Device	TC1762
Marking/Step	EES-AB, ES-AB, AB
Package	PG-LQFP-176-2

This Errata Sheet describes the deviations from the current user documentation. The module oriented classification and numbering system uses an ascending sequence over several derivatives, including already solved deviations. So gaps inside this enumeration can occur.

Figure 1

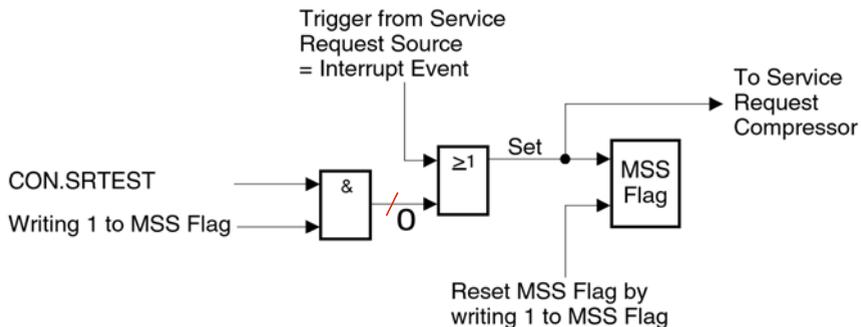
ADC_TC.023 Setting the MSS-flag doesn't generate an interrupt in TEST-MODE

It is possible to generate a software triggered interrupt event in TESTMODE (ADCx_CON.SRTEST=1) by setting one of the bitflags in register ADCx_MSS0/1. Due to the fact, that this mechanism is not working, it is not possible to generate a corresponding interrupt by software.

Do not use this software-generated interrupt in TESTMODE.

Figure 2 Timing concerning equidistant multiple timers

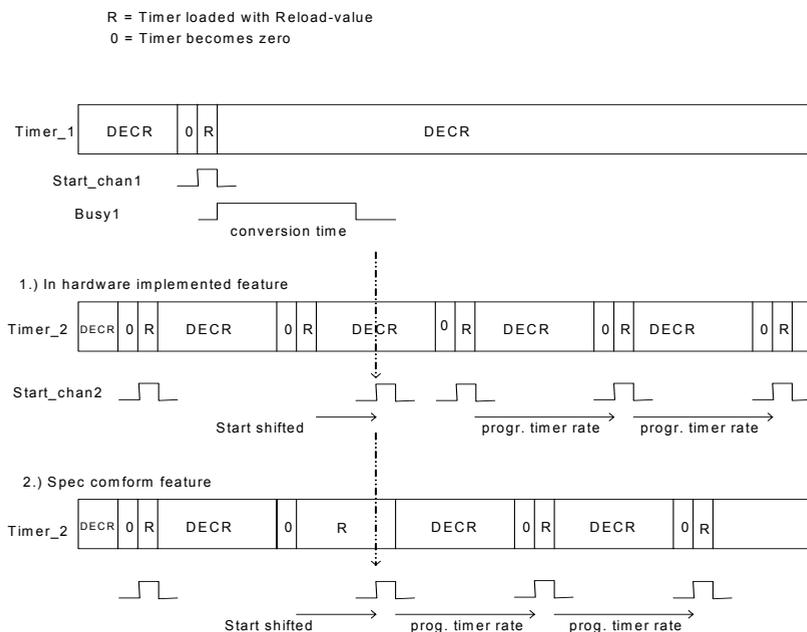
FADC_TC.005 Equidistant multiple channel-timers

The description is an example for timer_1 and timer_2, but can also affect all other combinations of timers.

Timer_1 and Timer_2 are running with different reload-values. Both timers should start conversions with the requirement of equidistant timing.

The correct behavior would be a reload when the requested conversion (of channel_2) is started.

Therefore the start of conversion for channel_2 is delayed by maximum one conversion-time. After this delay it will be continued with equidistant conversion-starts. Please refer to figure 1.

Figure 3 Uncritical transmission

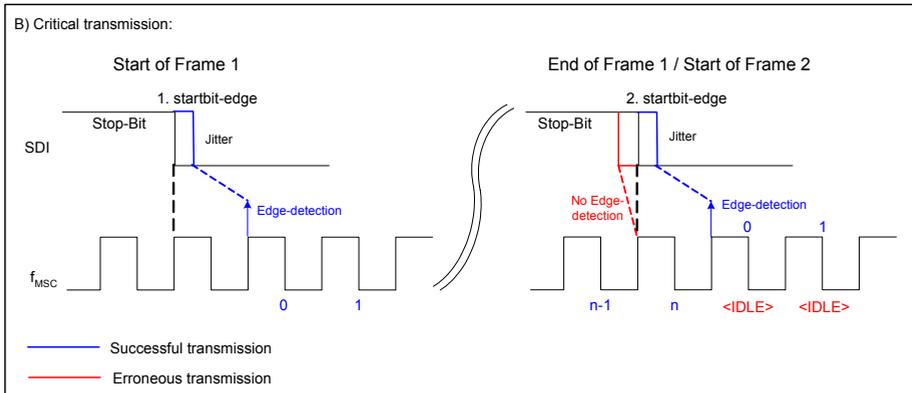
MSC TC.006 Upstream frame startbit not recognized

The MSC upstream-channel is able to receive multiple frames at the asynchronous input-pin without any interframe idle-time required.

As the falling startbit edge is shifted to the left of the rising clock edge (**Figure 3** left), there occurs a secure detection of the next startbit edge in the last cycle of the previous frame (here cycle n, **Figure 3** right) independent from the applied jitter to this edge.

Figure 5 Delay adjustment relative to the module clock

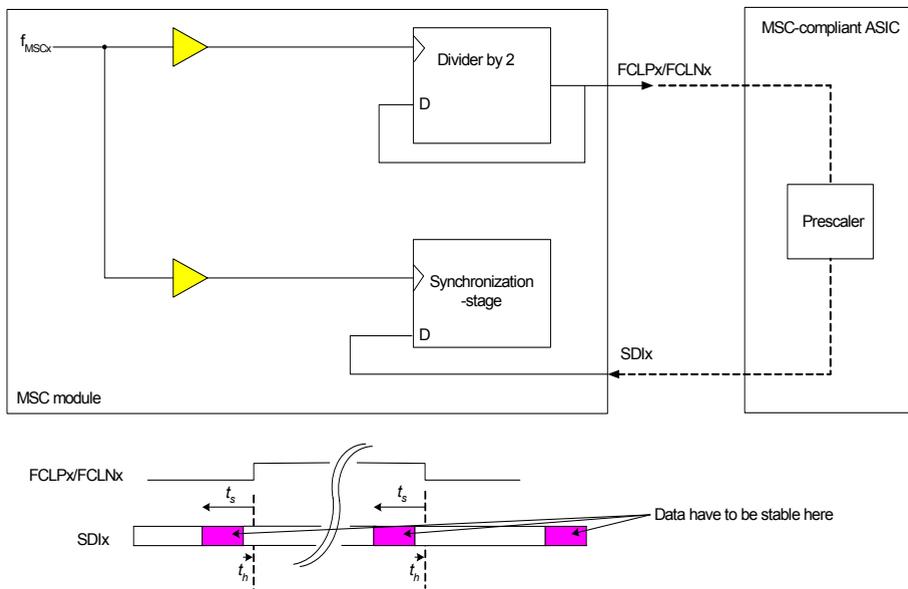
Figure 5 shows the principle blockdiagram of the input synchronization stage of the MSC module.

Setup/Hold-Times for SDI relative to FCLPx/FCLNx (valid for both edges):

The values for setup- and hold-times are listed in the following table. They were taken out of the timing analysis tool of the microcontroller device and apply to both, the rising and the falling edge.

Figure 9 Exemplary power up sequence
Reliability risk

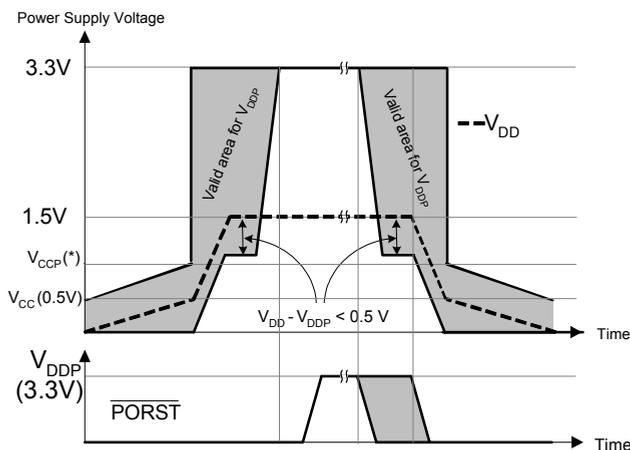
The power up sequence defined in the data sheet has to be additionally constrained. The following table classifies the V_{DD}/V_{DDP} ranges concerning cross-current severity.

Reliability risk

If $V_{DD} < 0.5 \text{ V}$, V_{CCP} must be $\leq 1.2 \text{ V}$ to avoid reliability risk. No risk was found for $V_{CCP} = 1.2 \text{ V}$ with 30 ms-long cross current pulses and 2.5 million power-ups @ 127°C .

As per Data Sheet, $V_{DD} - V_{DDP} < 0.5 \text{ V}$ has to be valid at any time in order to avoid increased latch-up risk. The figure below shows the possible V_{DDP} values as shaded region for an exemplary V_{DD} ramp. Moreover, the following rules apply:
